SUPPLEMENT TO THE APPLICATION FOR SITE CERTIFICATE FOR THE KLONDIKE III WIND PROJECT

Klondike III Wind Power Project

Response to First Request for Additional Information (RAI) – Dated July 8, 2005

Response to Second Request for Additional Information (RAI) - September 15, 2005

Figure L-1: Protected Areas, Oregon

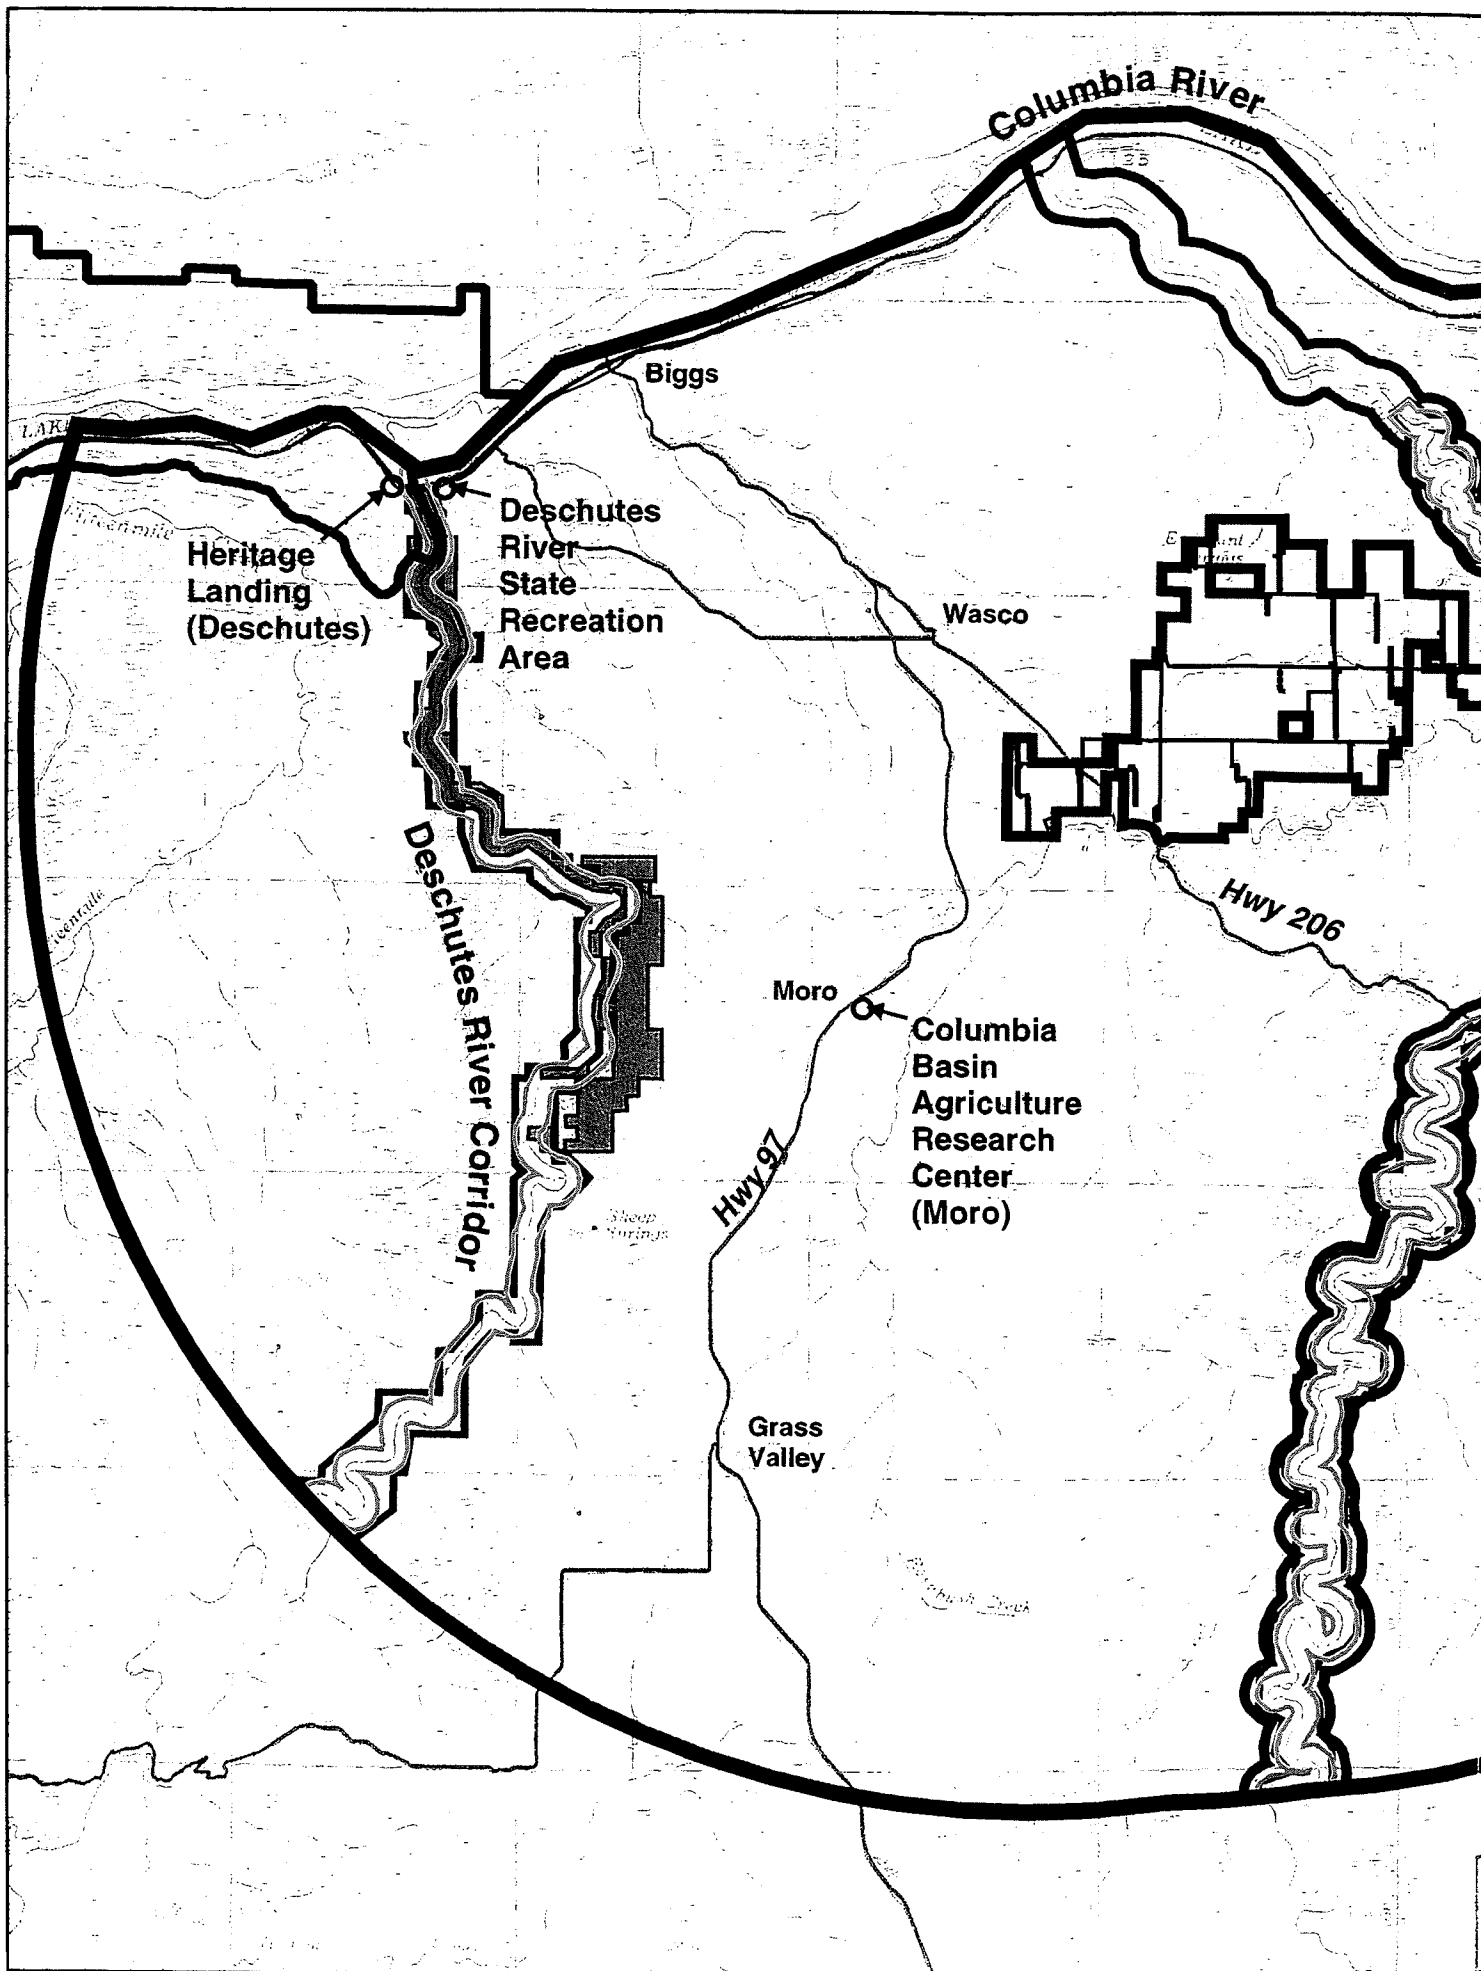
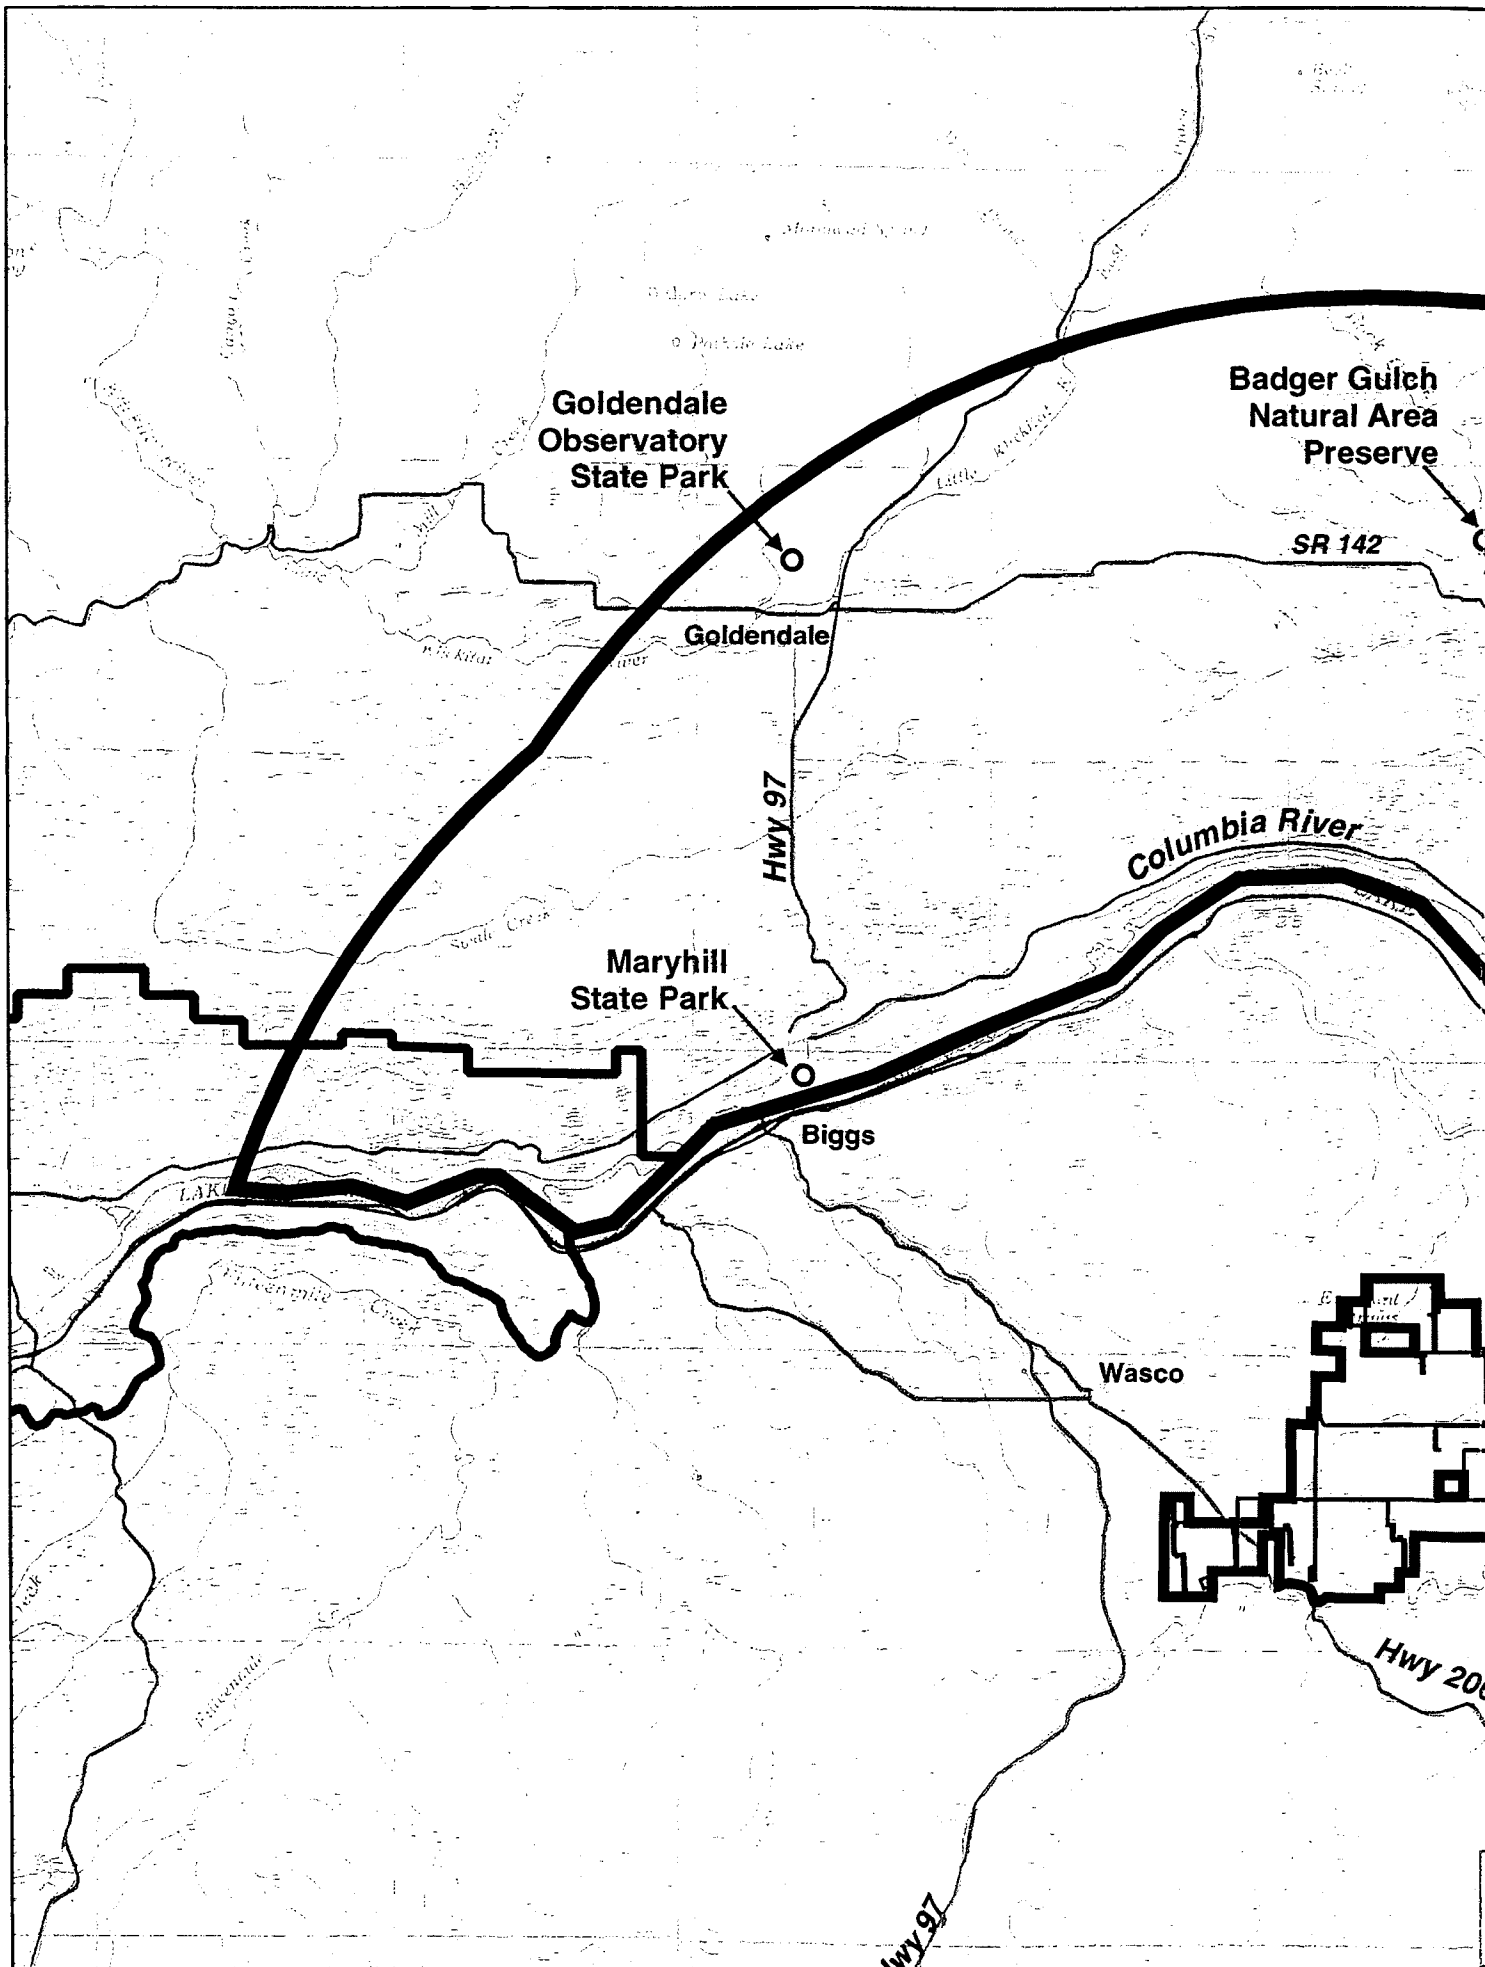
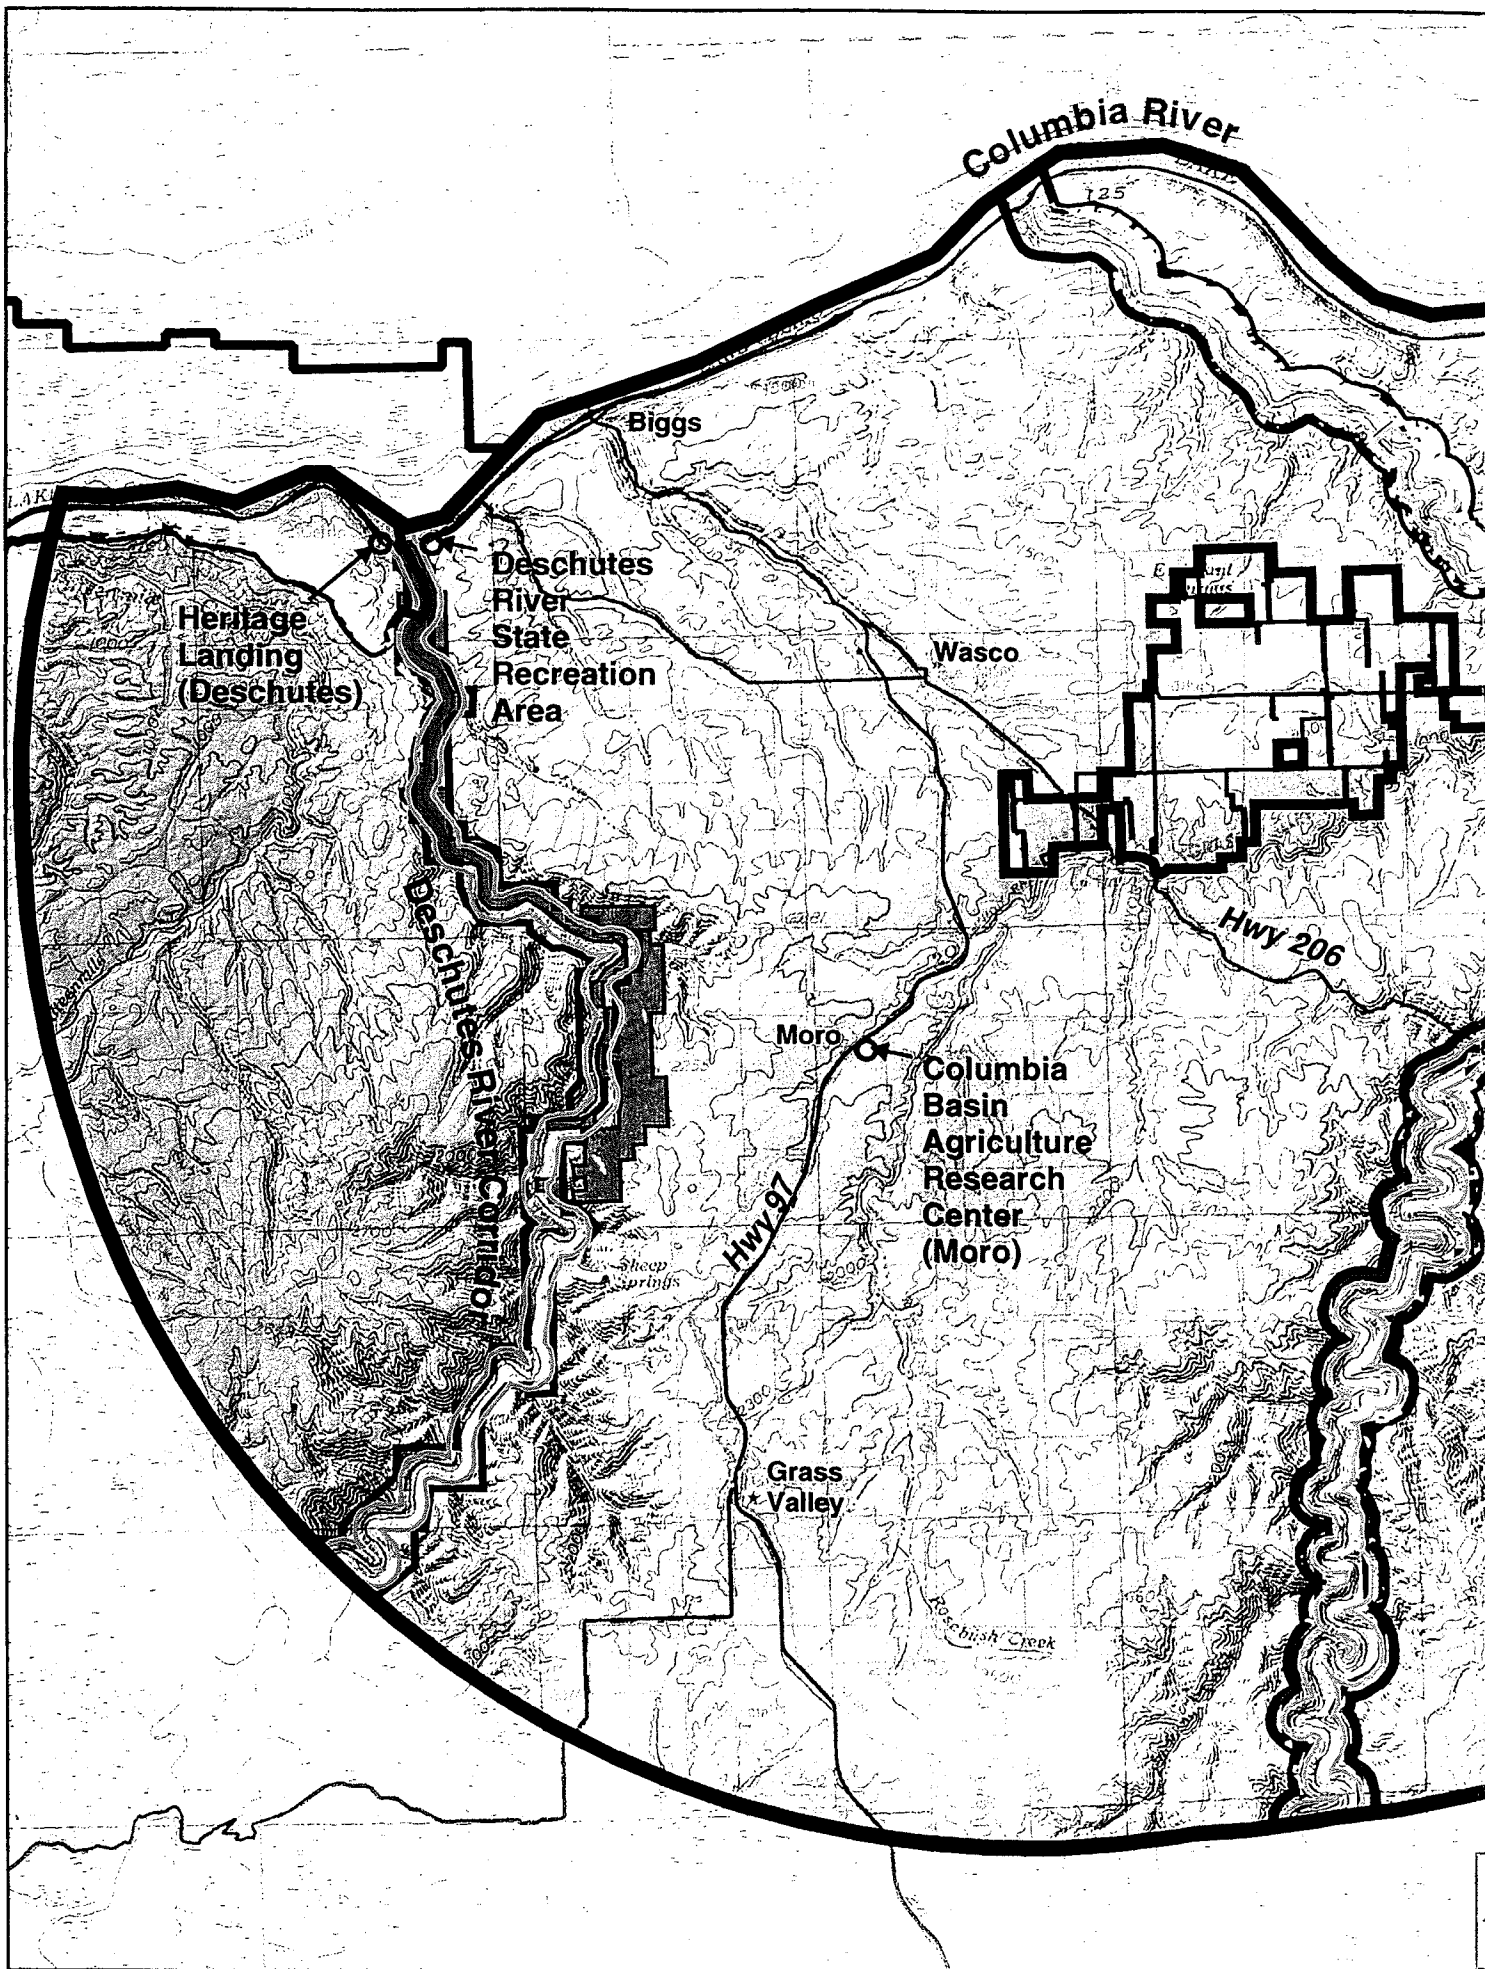
Exhibit L - Protected Areas		
L3	L-1	<p>Provide an analysis of any protected areas in the State of Washington that are within the 20-mile analysis area.</p> <p>Response: An analysis of State of Washington protected areas within the 20-mile analysis area is attached as Revised Exhibit L in Appendix L.</p>
L4	L-2	<p>Provide an analysis of whether noise from construction or operation of the proposed facility would be audible at any of the protected areas within the analysis area.</p> <p>Response: Noise levels from the wind turbine array were modeled at the three closest points on the boundary of the protected area (John Day Wildlife Refuge), approximately 0.8 miles away. No topographic shielding was included, making the model conservative. Sound levels from the turbines when all turbines are operating at the maximum sound power level are estimated to range between 27 and 30 dBA. This results in overall levels of 30 to 31 dBA when added to an assumed background level of 26 dBA. The increase over background levels would be 4 to 5 dBA during quiet background periods. An increase of 4 to 5 dBA is audible. At these low overall sound levels, the turbines might be audible in quiet areas away from flowing water during low wind conditions. However, it is probable that the sound could not be specifically identified to the source without visual cues.</p>

Response: The analysis area for impacts on Protected Areas includes the area within the site boundary and extends 20 miles beyond the site boundary in Oregon. As requested by ODOE, the analysis area has been expanded into Washington. Figures L-1 and L-2 illustrate the analysis area and 12 identified Protected Areas in Oregon and four identified Protected Areas in Washington, respectively. Table L-1 lists these Protected Areas and their approximate minimum distance from the proposed facility.
